Item ID: D206-642-341 Accept *N900040100* Setup Start *NS1*
 Revision ID: Stop *NS2*
 Item Name: Replacement Skidtube (Fits LH or RH)
 Start Date: 8/14/2015 Start Qty: 1.00 ** Cust Item ID:
 Required Date: 8/14/2015 Req'd Qty: 1.00 ** Customer:
 Reference:

DRAWING NO. D2650	TITLE 206/407 SKIDTUBE ASSEMBLIES	REV. F	DART AEROSPACE LTD ENGINEERING ORDER		D.E.O. NO. D2650-F-1	SHEET NO. SHEET 1 OF 1	SCALE NTS
DRAWN <i>JP</i>	CHECKED <i>A.P.</i>	MFG. APPR. <i>AA</i>	APPROVED <i>TH</i>		DE APPR. <i>TH</i>		
DATE 12.10.12	DATE 12.10.22	DATE 12.10.22	DATE 12.10.22		DATE 12.10.22

CHANGE C'BORED WELDED CROSSBOLT SPACERS TO SWAGED SPACERS

DETAIL G

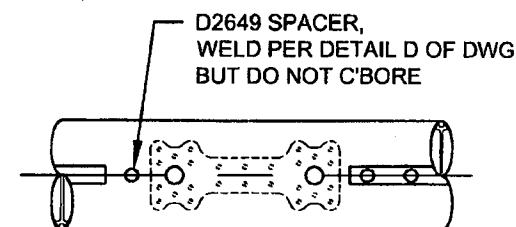
ADD DETAIL G BELOW, WHICH IS THE SAME SECTION VIEW AS DETAIL D OF DWG.

AFTER DRILLING AND BENDING ASSEMBLY
PERFORM THE FOLLOWING FOR Ø0.375 HOLES THAT ARE
CURRENTLY C'BORED:

1. INSERT D4720-1 SPACER, 16 PL (-1) OR 17 PL (-3)
OR 19 PL (-5) OR 23 PL (-7)
2. SWAGE TO Ø0.313 X 0.75 DP PER QSI 002
3. TRIM / GRIND FLUSH PER QSI 002

AMENDMENT TO DETAIL B
NOT TO SCALE

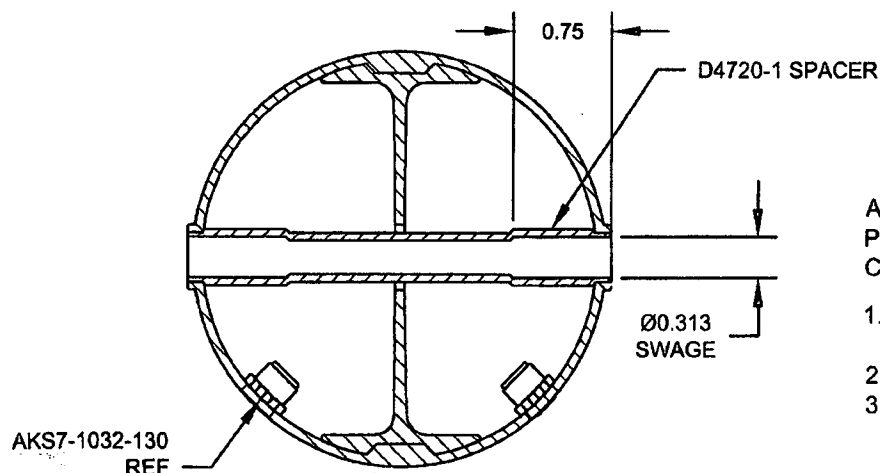
C'BORED HOLES ARE **NOW SWAGED** PER DETAIL G BELOW. FOR THE Ø0.375 HOLE THAT IS NOT C'BORED, WELD PER DETAIL D OF DWG (SEE AMENDED DETAIL B FOR REFERENCE).
